T.I. no.: 2019 - 22 Updated: -	Topic: Brewing unit spacer sleeve SCA P / SCSoul
---	---

Simplifying assembly on the brewing unit

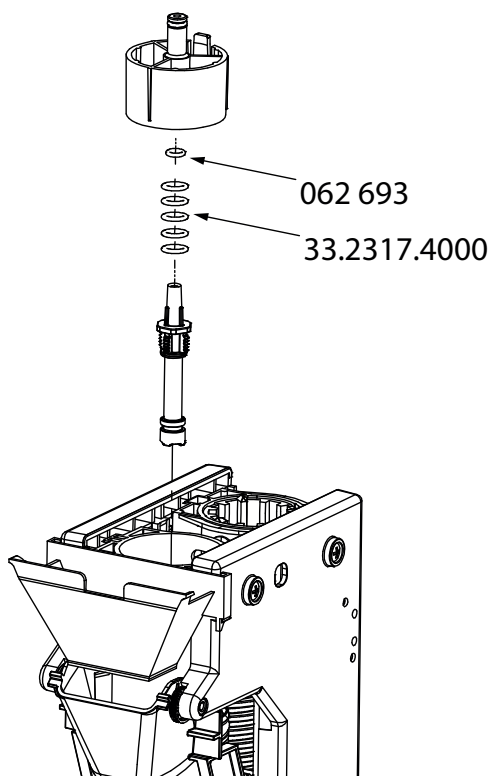
In the 30 g brewing unit, five spacer washers **33.2317.4000** are replaced by a spacer sleeve **075 653**.

5 SPACER WASHERS

33.2317.4000 OLD

The new spacer sleeve replaces five spacer washers, thereby simplifying assembly work on the brewing unit, the restrictor insert and the adapter.

1 SPACER SLEEVE

075 653 NEW
